PLANNING REPORT

Architectural Review Board

Teriyaki Madness 25-049MPR

Address	16 N. High Street
Proposal	Modifications to a Landmark building and associated site improvements on a 0.26-acre site.
Request	Review and approval of Minor Project Review (MPR) under the provisions of Zoning Code Section 153.176
Zoning	HD-HC, Historic Core District
Planning Recommendation	<u>Approval of Minor Project Review with Conditions.</u>
Next Steps	Upon approval of the Minor Project Review, the applicant may apply for building permits through Building Standards.
Applicant	Paige Fleming, Tim Lai Architect
Case Manager	Rati Singh, Assoc. AIA, Planner II (614) 410-4533 rsingh@dublin.oh.us

Outbuilding facing N. Blacksmith Lane; original doors on right

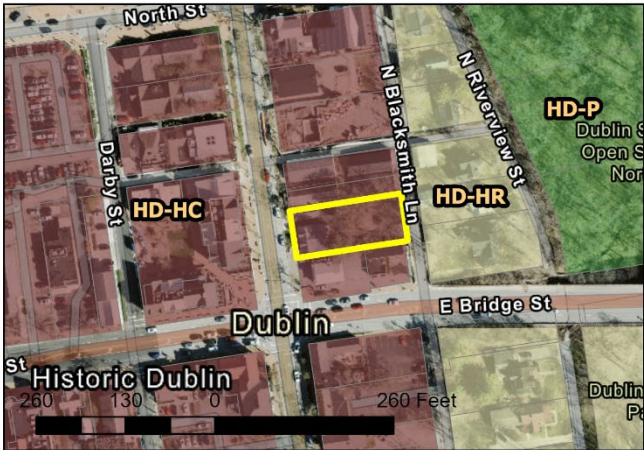
The applicant also plans to clean the existing outbuilding facing Blacksmith Lane and enclose the openings with painted Hardie Board panels. During the review process, staff recommended that the Hardie Board "door" panels include hardware, such as hinges, to ensure that the panel reflect the original intent of the outbuilding. The *Historic Design Guidelines* recommend that when outbuildings need repair or replacement of deteriorated elements, new materials should match the old. Staff recommends the applicant work with staff to provide details prior to Building Permit as a condition of approval.

- c. Hardware details (Outbuilding panels)
 - d. Umbrella base and pole in black color
 - e. Light fixture details (restoration, installation height and details, and wattage)

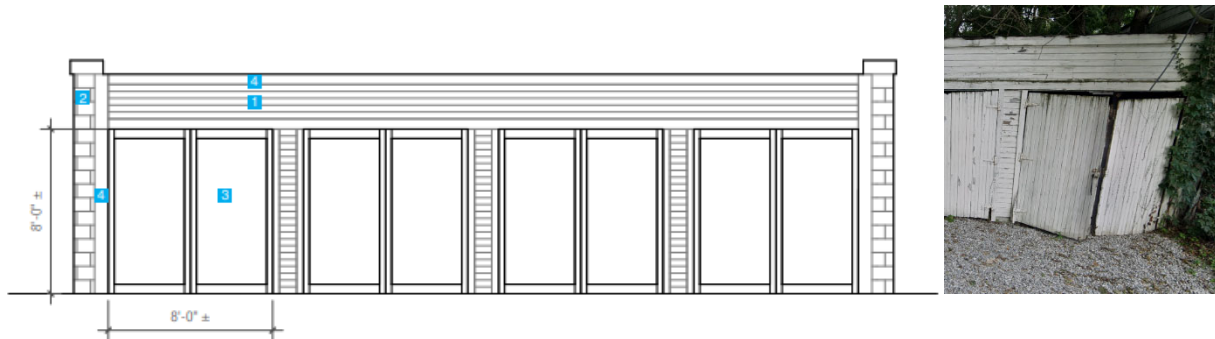
The applicant proposes to remove the existing High Street curb cut along with the surrounding conditions and replace them with a seeded or grassed tree lawn and a curb along the right-of-way. The Board supported the request at the Informal Review. The applicant is proposing no on-street parking with the request. However, if on-street parking spaces can take the place of the current curb cut, a striping and signing plan will need to be provided during the site permit stage. A condition of approval addresses this.

The applicant proposes to replace the asphalt driveway between the existing buildings with a pedestrian walkway to create a corridor from N. High Street to the rear of the site, enhanced by foundation plantings on both sides. The applicant also proposes to resurface the existing rear driveway and restripe the parking lot including the creation of a required ADA parking spot.

- 4) The applicant shall provide a striping and signing plan if on-street parking spaces can take the place of the current curb cut as determined by staff, during Site Permit.
